AGENDA

Committee	PWYLLGOR CYNLLUNIO
Date and Time of Meeting	DYDD MERCHER, 23 IONAWR 2019, 1.30 PM
Venue	YSTAFELL BWYLLGORA 4 - NEUADD Y SIR
Membership	Councillor Keith Jones (Cadeirydd) Councillors Lay, Ahmed, Asghar Ali, Congreve, Driscoll, Gordon, Hudson, Jacobsen, Jones-Pritchard a/ac Sattar

PLANNING COMMITTEE

Title
Proposed Ground & First Floor Plans

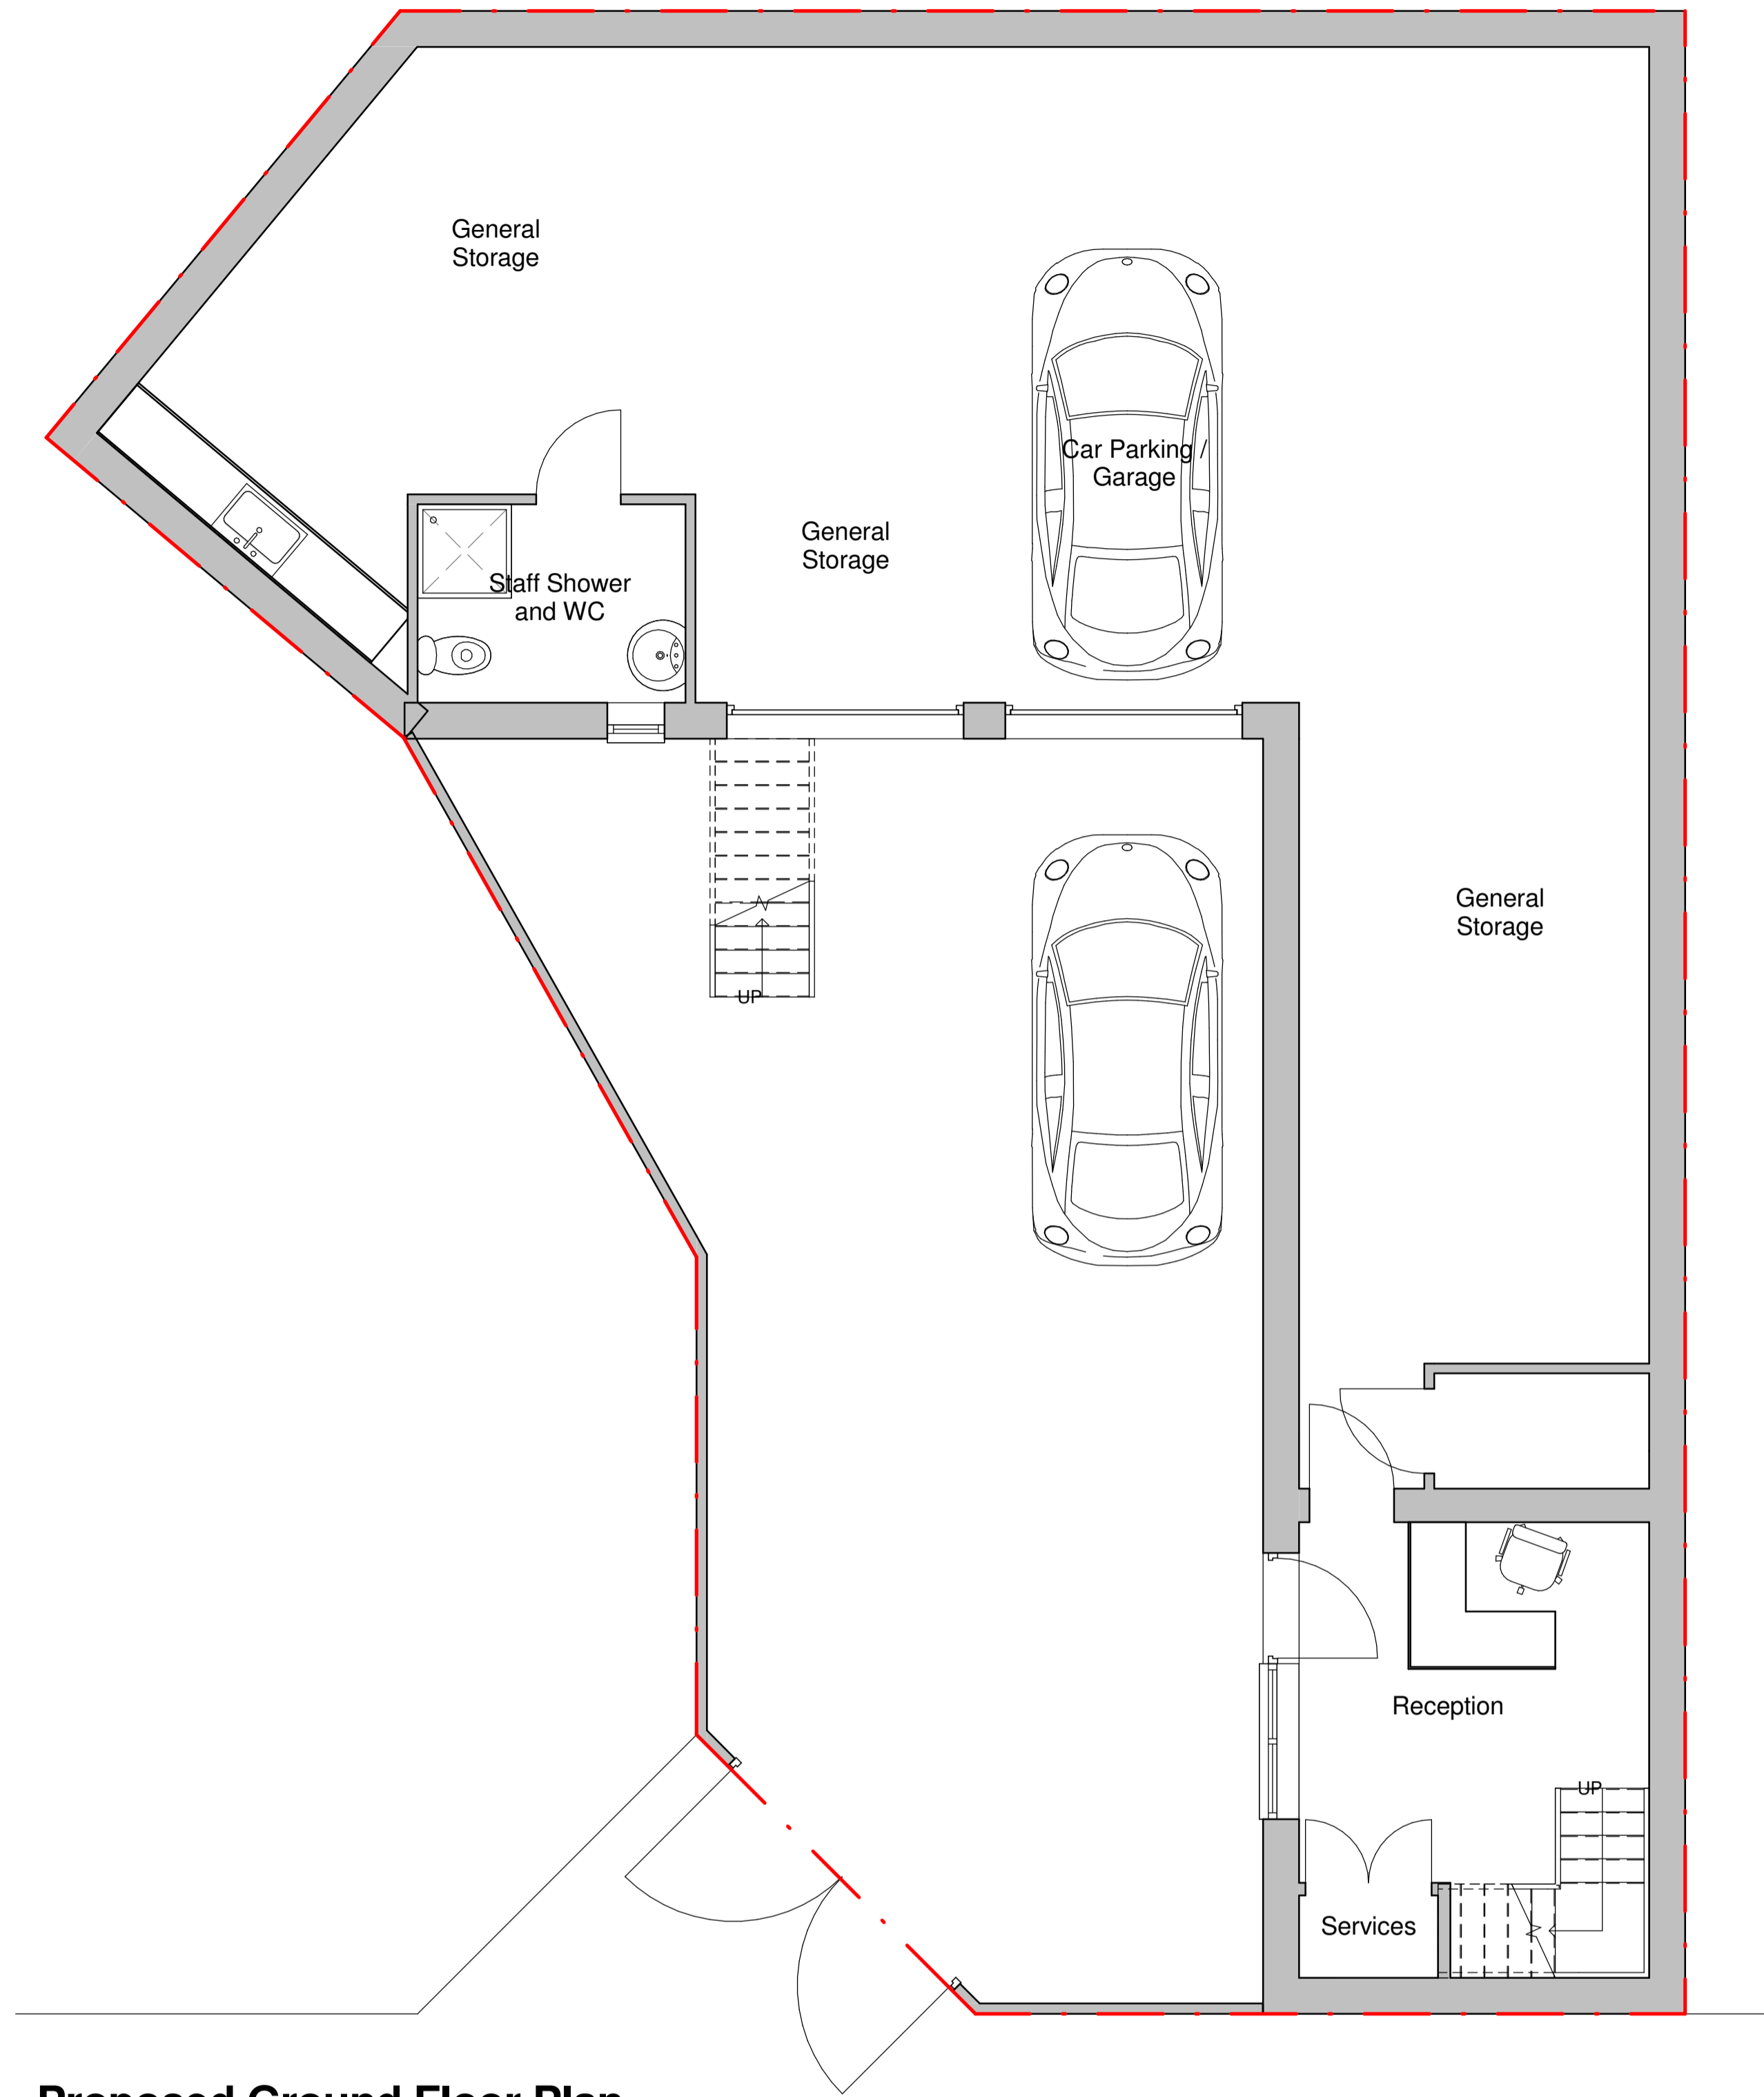
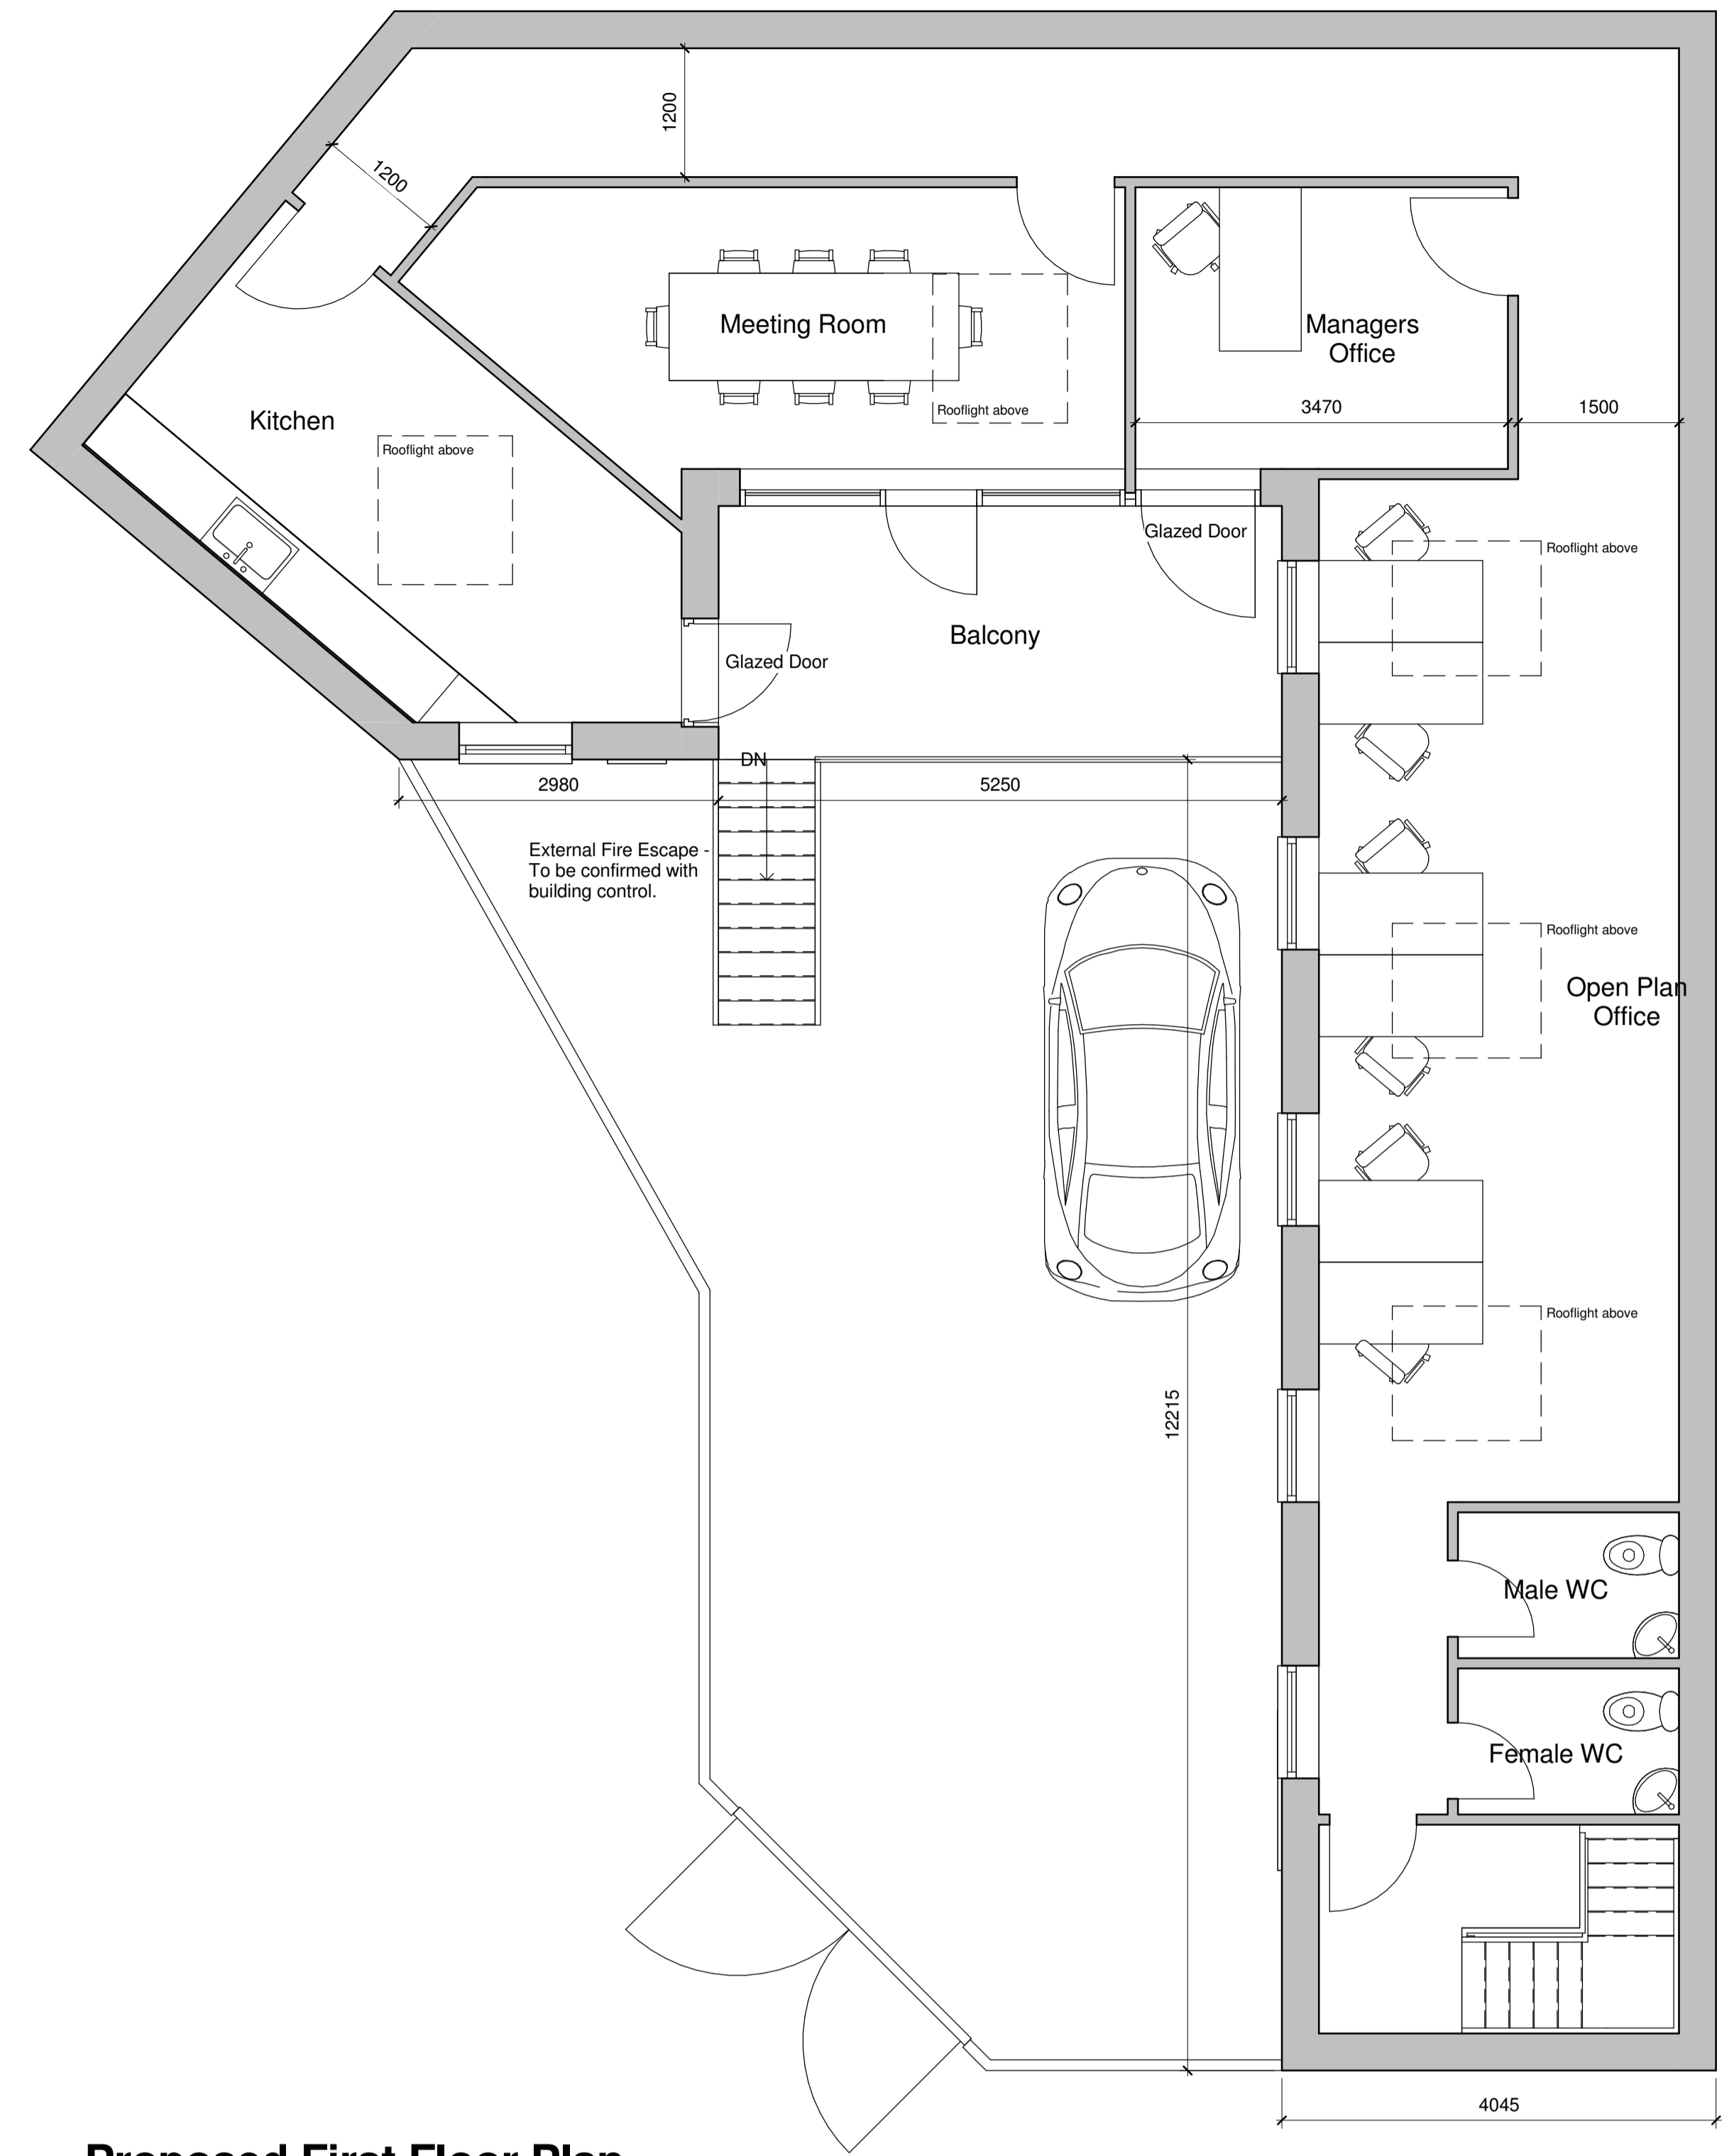
described or shown on the plans. As a result of the proposal, the total area of the yard would reduce, and the proposed plans indicate a new ground floor garage/parking space within the building, and a vehicle space behind it beyond the building. Whilst only two parking spaces are marked, it would appear there is room for at least one further space, although this arrangement would result in an apparent lack of room for vehicles to manoeuvre.

The Design Statement says that “Parking facilities will be increased by raising the office space to allow 2 cars to be parked in the ground level as well as the existing surface parking that is currently on the site.” Based on the submitted plans it does not appear there is an increase in parking at the site, although it may be there is an increase in marked/dedicated parking areas. This should be clarified.

According to our standards the application would need to include a minimum of 2 cycle parking spaces for staff, and this should be covered and secure. In addition one space for visitors should be provided. No cycle parking is marked on the plans. However, the requirements are based on the ‘General Industry’ category, although looking at the plans it seems that the new building areas may be more appropriate for the general ‘Business’ parking standards category (i.e. offices, meeting room), which would have different parking requirements.

8.5 The submitted plans show the provision of a first floor balcony, external staircase and first floor windows facing towards no 8 Ty Mawr Road. There are concerns that these elements would allow overlooking and a loss of privacy to the occupiers of no.8 Ty Mawr Road due to their close proximity. The staircase
